**TOWN OF NEWBURGH
PLANNING BOARD
TECHNICAL REVIEW COMMENTS**

PROJECT NAME: UNIFIRST
PROJECT NO.: 2021-14
PROJECT LOCATION: SECTION 34, BLOCK 2, LOT 38.32
REVIEW DATE: 26 AUGUST 2021
MEETING DATE: 2 SEPTEMBER 2021
PROJECT REPRESENTATIVE: PITINGARO & DOETSCH

**Subject: UniFirst Corporation – SBL: 34-2-38.32
33 Jeanne Drive Town of Newburgh, NY
Project #2021-14**

SITE PLAN

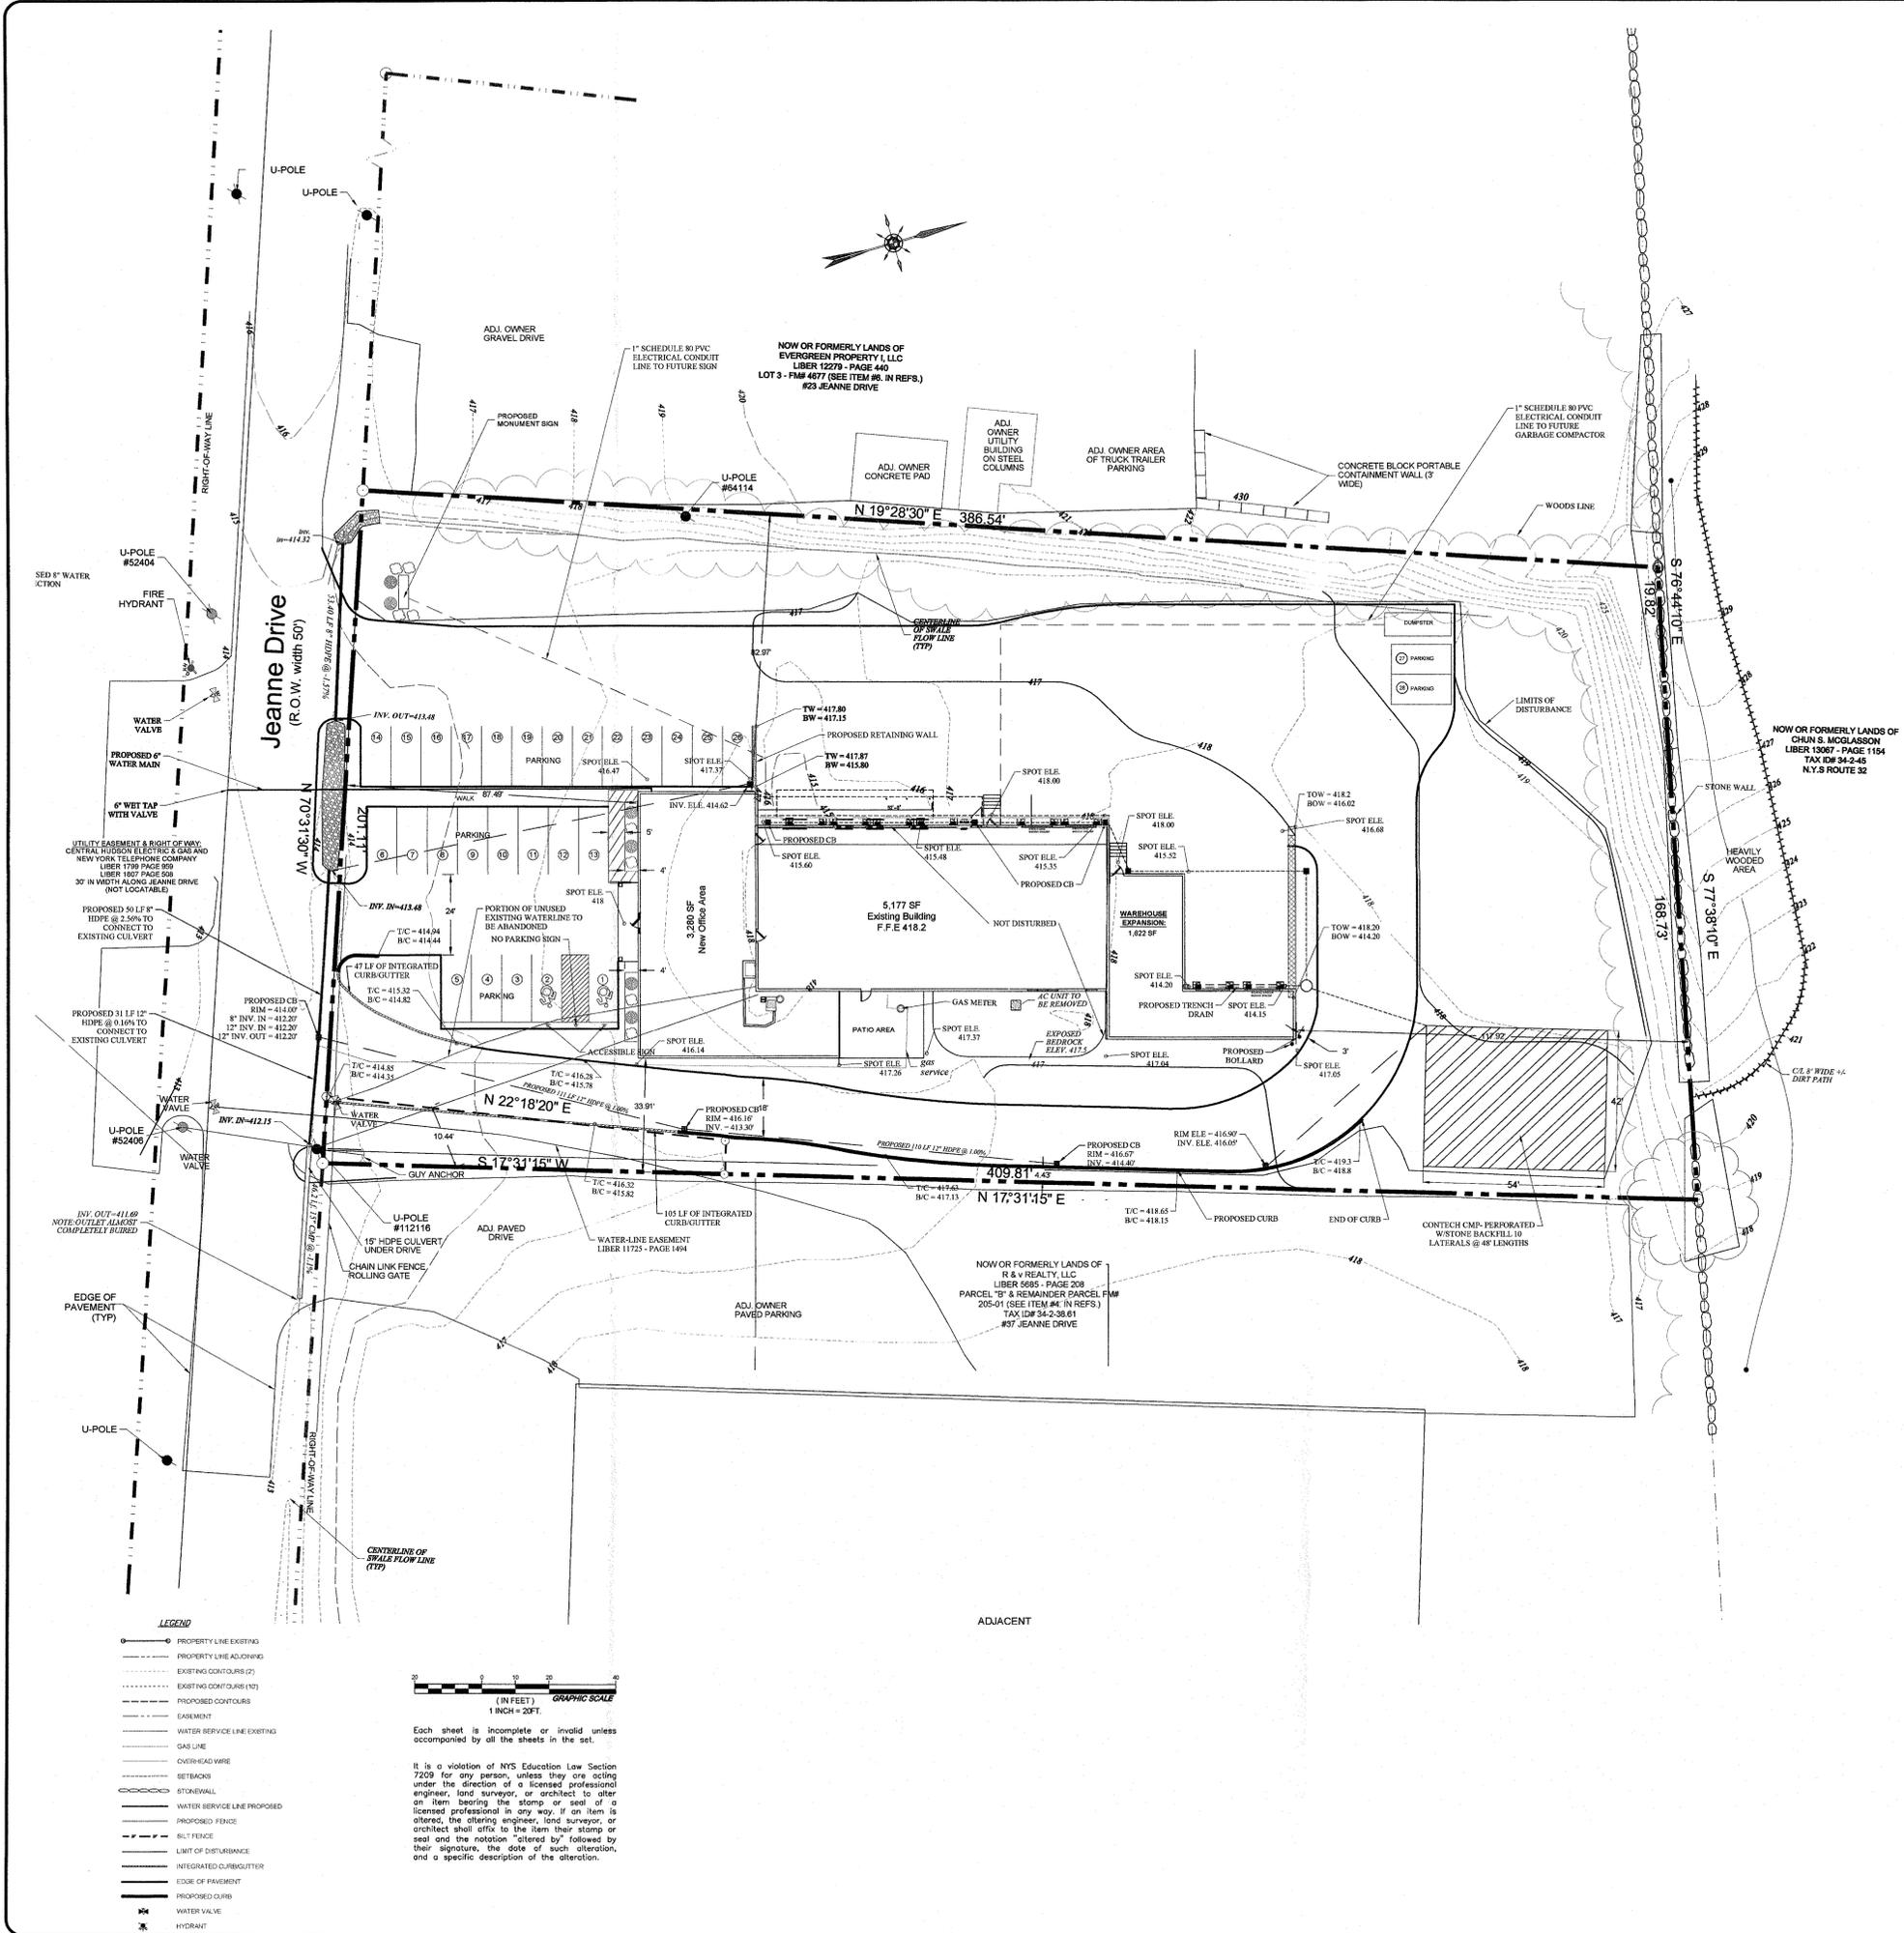
1. The Applicants have provided an updated Stormwater Management Report and SWPPP for the project. This office has reviewed the report and takes no exception to the report as prepared.
2. Based on our previous comments the new driveway has been adjusted away from the neighbors lot line.
3. This office has reviewed an Environmental Assessment Form prepared for the project and would recommend a Negative Declaration as no significant environmental impacts have been identified.
4. The Planning Board should determine whether a Public Hearing should be held for the Amended Site Plan in the commercial corridor.

3. Proposed new driveway is very close to the adjoining property. It is not clear it can be constructed without impacting the adjoining property. The property lines should be drawn to be clearer on the plans.
The proposed new driveway was located approximately five (5) feet from the property line, but it has since been adjusted to be outside of the neighboring lot's easement to protect the existing water service.
